City of Biddeford
Planning Board
September 29, 2021 6:00 PM City Hall
Council Chambers, & via ZOOM
Sep 29, 2021 06:00 PM Eastern Time (US and Canada)
Topic: Planning Board

- 7.D. Final Site Plan/Subdivision Review and a Public Hearing and make a recommendation to the City Council regarding a proposed Contract Zone for Adams Point, LP and Southern Maine Affordable Housing at 69 Adam's Street (Tax Map 38, Lot 296) to allow for 39 units of multi-family housing in a structure not to exceed 60 feet in height (5 stories) as measured from grade to the highest roof beams of a flat roof, excluding any parapets for elevators, roof access, or the screening of mechanical equipment, and to provide less than 1 parking spaces per unit. Multi-family housing is a permitted use in the underlying zone (MSRD-2).

[4.0 Board Report - Adams Point Final Plan-rv \(929 MTG\).pdf](#)

STOR1 STORMWATER STORAGE AND
OCS1 OUTLET CONTROL STRUCTURE DETAIL

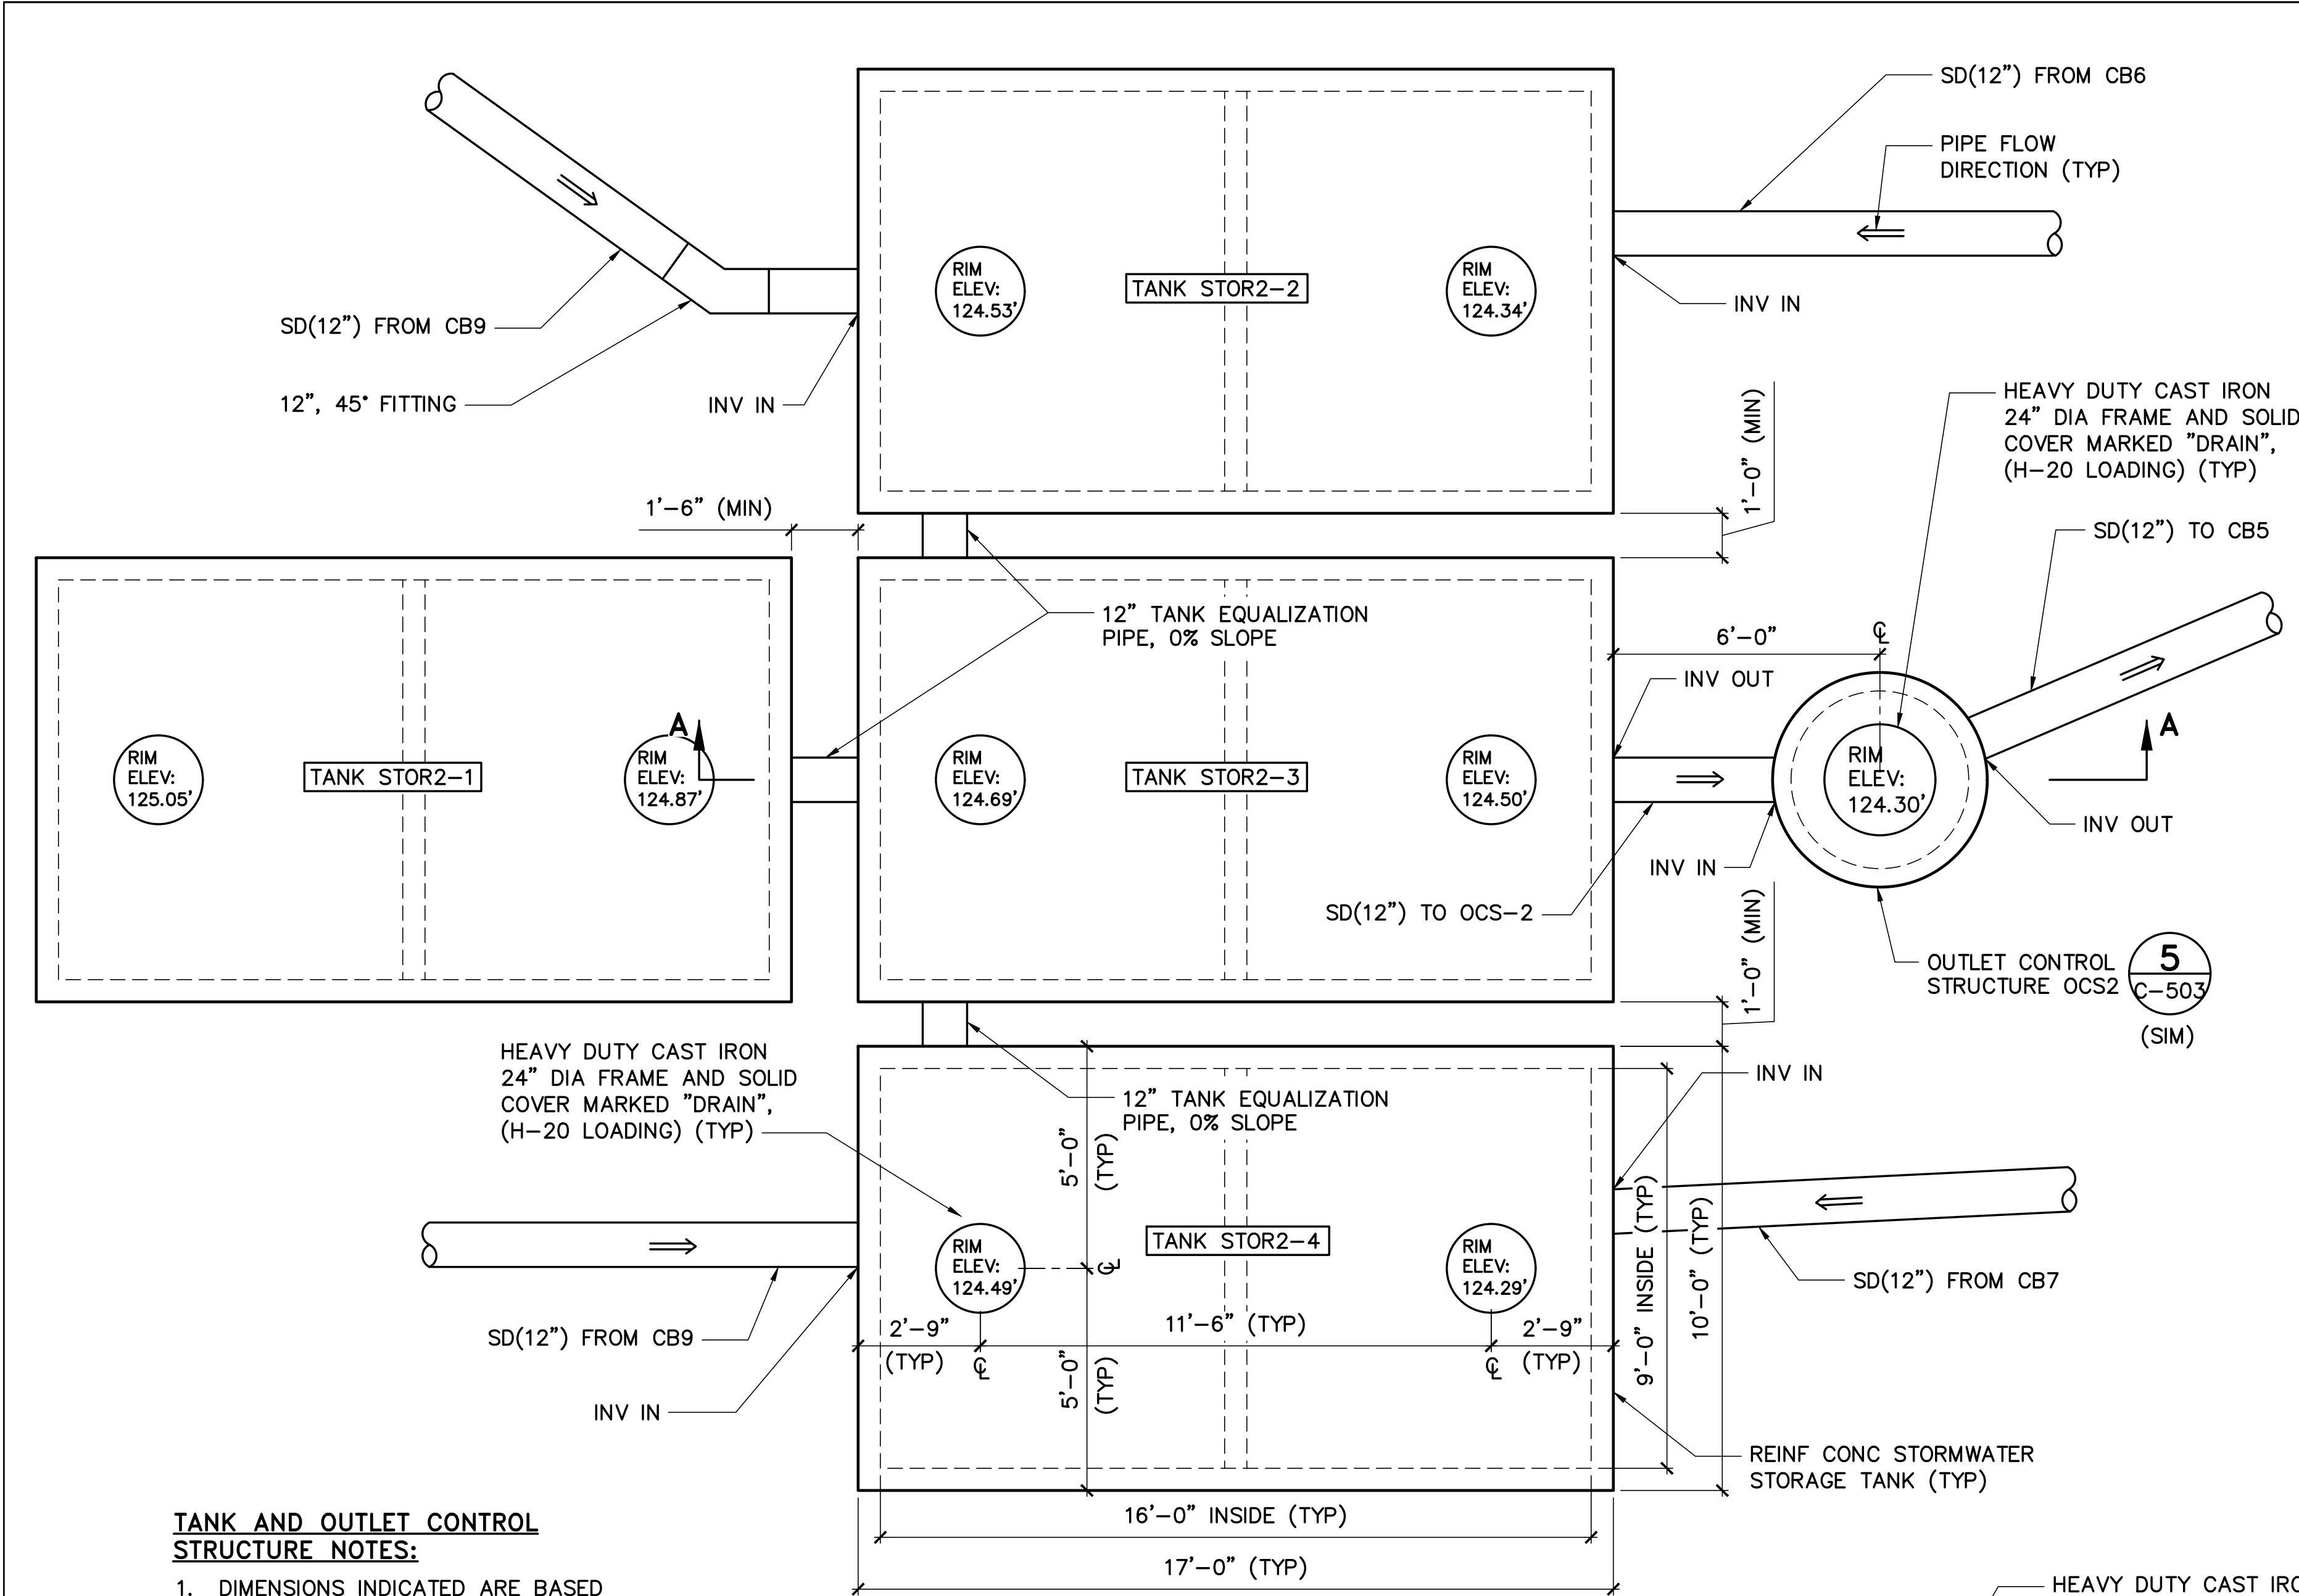
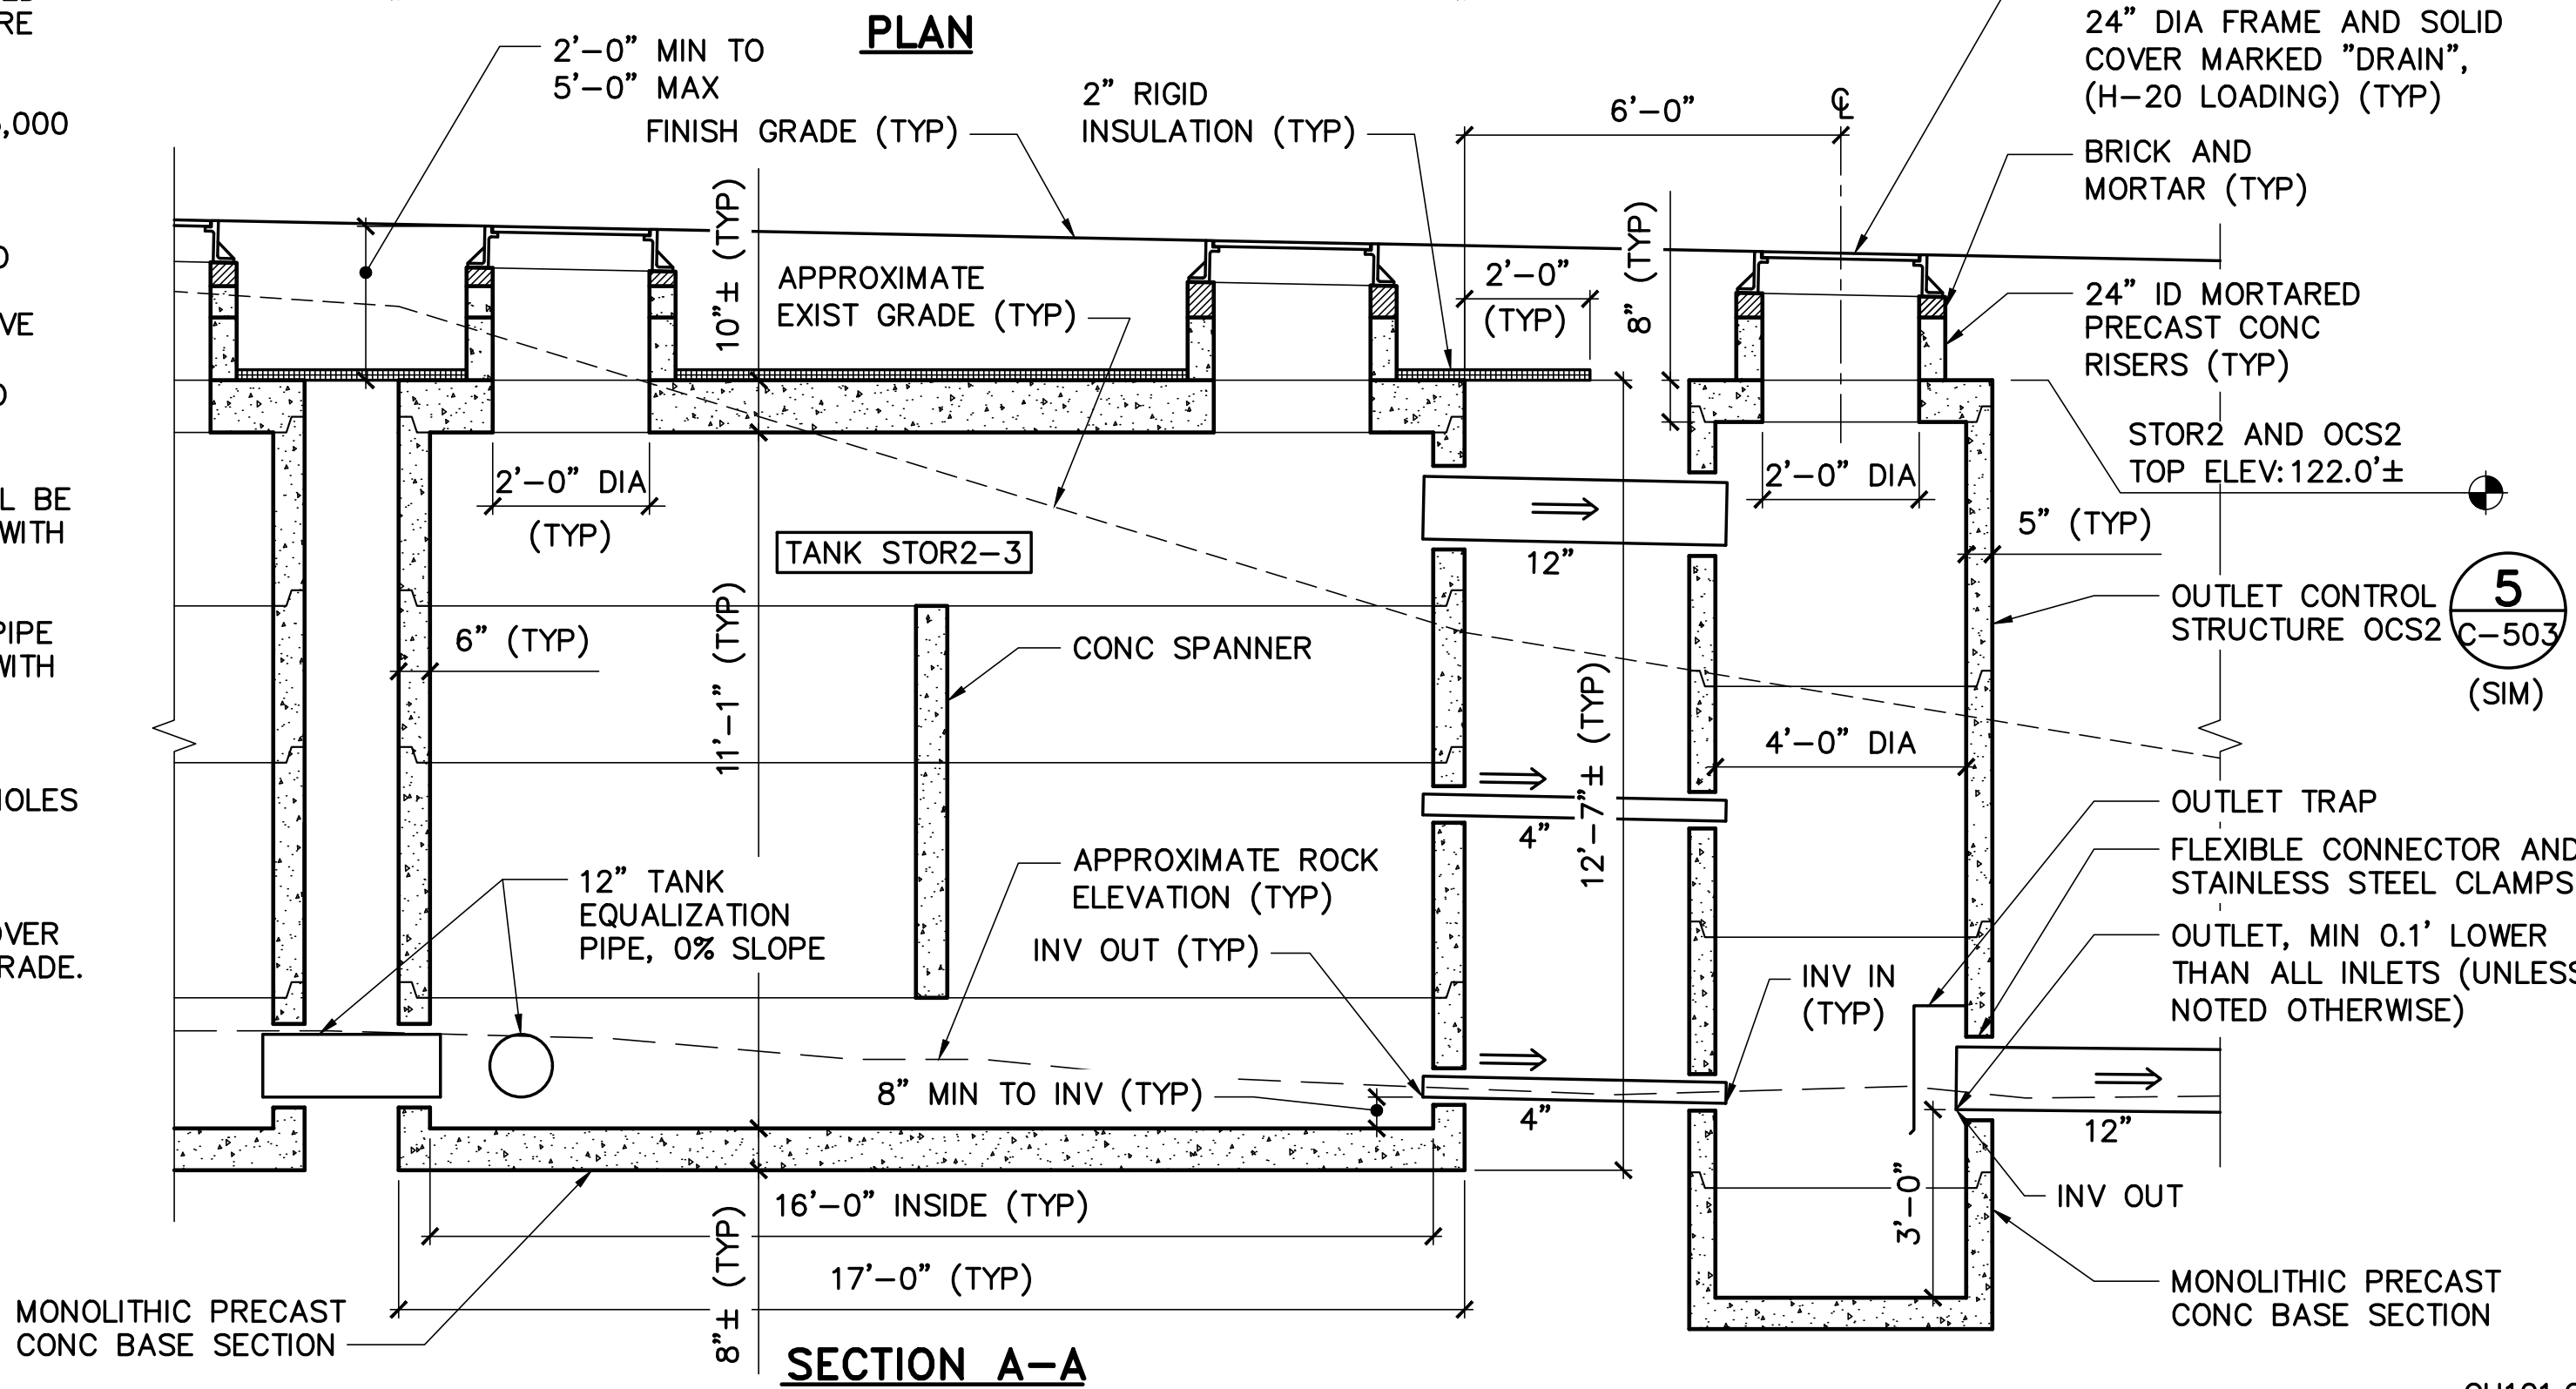
- Sheet C-504

- o Detail 1 – separate details/plans/sections should be provided for each individual detention system (STOR-1 and STOR-2) with proposed rim/invert/bottom elevations identified. **Response: Details for each storage system have been provided.**
- o Manufacturer/model name identified, or standard details provided. **Response: There are no manufacturer specific items and standard details are provided.**
